Document last modified: 4/13/15

<u>Page</u>	<u>Correction</u>
iii	Karl Kerchner , Lebanon County Conservation District
3	URL link has been changed to: http://www.deq.virginia.gov/Portals/0/DEQ/Water/Publications/TechBulletin1.pdf
35	3 rd paragraph, 1 st sentence: 2,000 cubic feet storage capacity (with 12” freeboard) for each tributary drainage acre.
62	Last paragraph, 1st sentence: “As with other sediment barriers, compost socks should not be placed in areas of concentrated flow. They should be placed parallel...”
64

**STANDARD CONSTRUCTION DETAIL # 7-12
Sediment Basin Emergency Spillway with Riprap Lining**

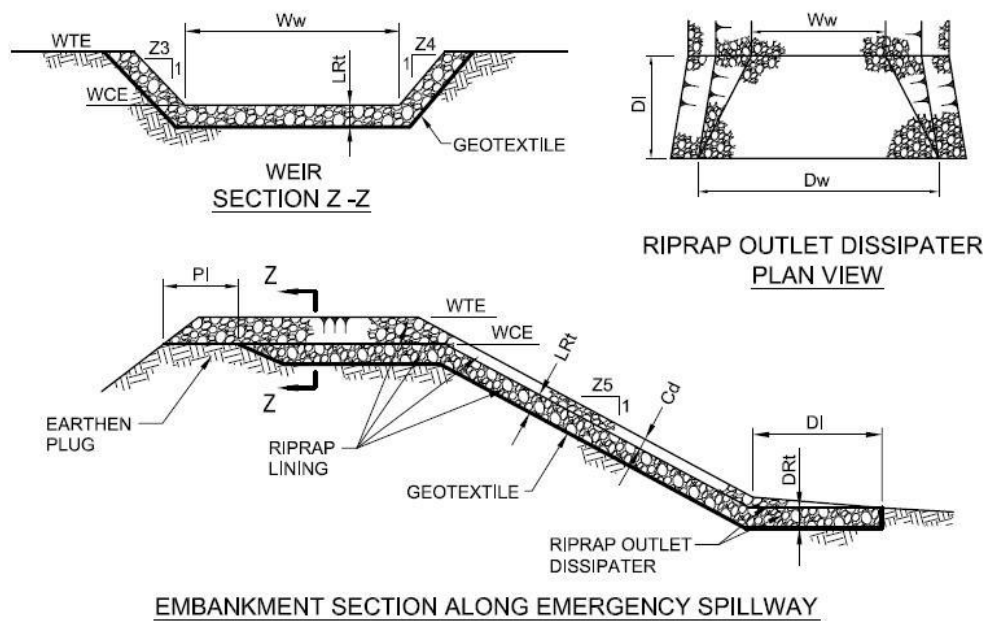
193

STANDARD CONSTRUCTION DETAIL # 13-4

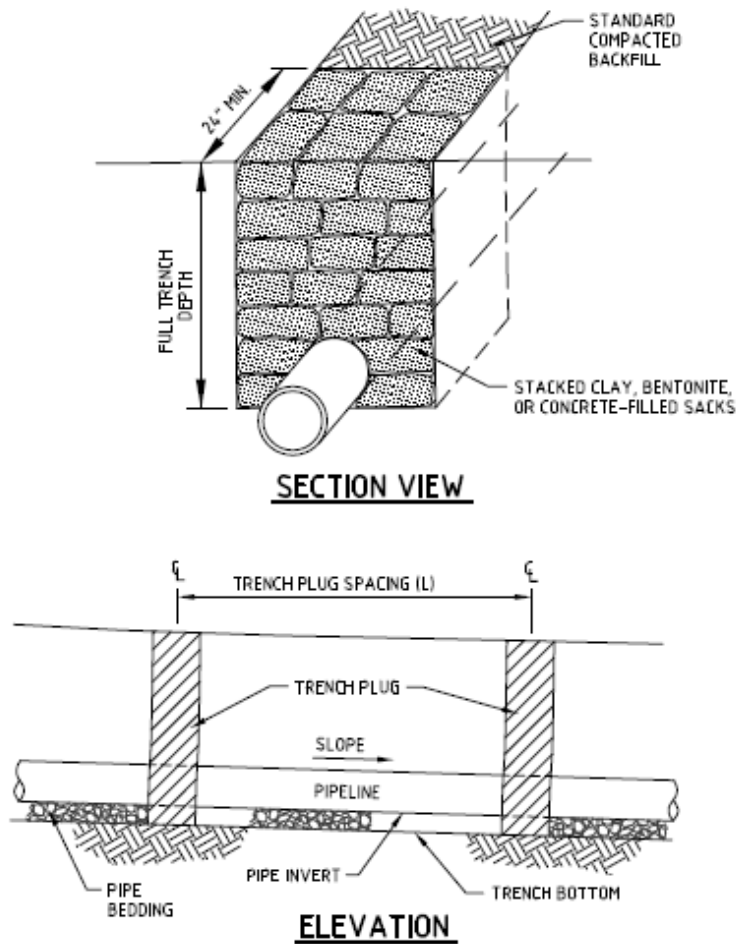
- 266 Table 11.2 should state that the Permanent Fertilizer Type/rate would be 10-20-20 at 1000 lbs./ac
- 268 2. If high-quality seed is used, for most sites seed spring oats at a rate of 2 bushels per acre, winter wheat at **1.5** bushels per acre, and winter rye at 1 bushel per acre. If germination is below 90%, increase these suggested seeding rates by 0.5 bushel per acre.
- 278 Topsoil should be applied and prepared as described on page 263 prior to sod placement.
- 281 Figure 11.6, Notes: 1. CELLS SHALL BE ANCHORED SECURELY TO PREVENT DISPLACEMENT...
